Access Compliance Report

Public Rights-of-Way

(Pedestrian Signals)

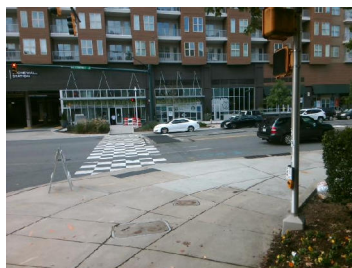
PROW/ADA: TMUTCD 4e.08, R404.2, R406.2, , R404.3

Compliance	Description	Data	Compliance	Description	Data
	Button Count	Button2	N/A	Distant to Additional Button (in)	N/A
	Additional Button Present?	N/A		Additional Button ID	N/A
N/A	Signal Buttons Required?	N/A	N/A	Additional Ped Posts Required	N/A
	How Many Ped Street Xings?	2		Located In An Island/Median?	No
N/A	B 1 Sign Present?	Yes	N/A	B 2 Sign Present?	Yes
Yes	B 1 Sign Purpose?	Yes	Yes	B 2 Sign Purpose?	Yes
Yes	B 1 Sign Lettering & Contrast?	Yes	Yes	B 2 Sign Lettering & Contrast?	Yes
Yes	B 1 Parallel To XWalk?	Yes	Yes	B 2 Parallel To XWalk?	Yes
Yes	B 1 PAR to Button?	Yes	Yes	B 2 PAR to Button?	Yes
Yes	B 1 PAR to XWalk?	Yes	Yes	B 2 PAR to XWalk?	Yes
Yes	B 1 Clear Floor Space?	Yes	Yes	B 2 Clear Floor Space?	Yes
N/A	B 1 FWD Approach?	Yes	N/A	B 2 FWD Approach?	Yes
N/A	B 1 FWD Approach Constrained?	No	N/A	B 2 FWD Approach Constrained?	No
No	B 1 FWD Approach Reach (in)	4.0	No	B 2 FWD Approach Reach (in)	9.0

N/A	B 1 FWD Approach Width (in)	N/A	N/A	B 2 FWD Approach Width (in)	N/A
N/A	B 1 FWD Approach Obstruction?	Yes	N/A	B 2 FWD Approach Obstruction?	Yes
N/A	B 1 FWD Approach Obstruction Dist (in)	4.0	N/A	B 2 FWD Approach ObstructionDist (in)	5.0
N/A	B 1 PARA Approach?	Yes	N/A	B 2 PARA Approach?	Yes
N/A	B 1 PARA Approach Constrained?	No	N/A	B 2 PARA Approach Constrained?	No
Yes	B 1 PARA Approach Reach (in)	4.0	Yes	B 2 PARA Approach Reach (in)	5.0
N/A	B 1 PARA Approach Width (in)	N/A	N/A	B 2 PARA Approach Width (in)	N/A
N/A	B 1 PARA Approach Obstruction?	Yes	N/A	B 2 PARA Approach Obstruction?	Yes
N/A	B 1 PARA Approach Obstruction Dist (in)	4.0	N/A	B 2 PARA Approach ObstructionDist (in)	5.0
Yes	B 1 Clear Floor Space Slope (%)	1.3	No	B 2 Clear Floor Space Slope (%)	6.0
No	B 1 Clear Floor Space XSlope (%)	6.6	No	B 2 Clear Floor Space XSlope (%)	6.5
N/A	B 1 PAR Slope (%)	7.8	N/A	B 2 PAR Slope (%)	0.0
Yes	B 1 Height (in)	35.0	Yes	B 2 Height (in)	35.0

Yes	B 1 Clear Xing Direction?	ClearlyMarked	Yes	B 2 Clear Xing Direction?	ClearlyMarked
	B 1 Crossing Direction	To SW		B 2 Crossing Direction	To SE
Yes	B 1 DistanceTo XWalk (in)	17.0	Yes	B 2 DistanceTo XWalk (in)	31.0
No	B 1 DistanceTo Curb (in)	288.0	No	B 2 DistanceTo Curb (in)	277.0
Yes	B 1 Diameter (in)	2.0	Yes	B 2 Diameter (in)	2.0

Possible Solutions: Replace Signal Push Button With APS Button on New Post. Remove & Relocate Sign.
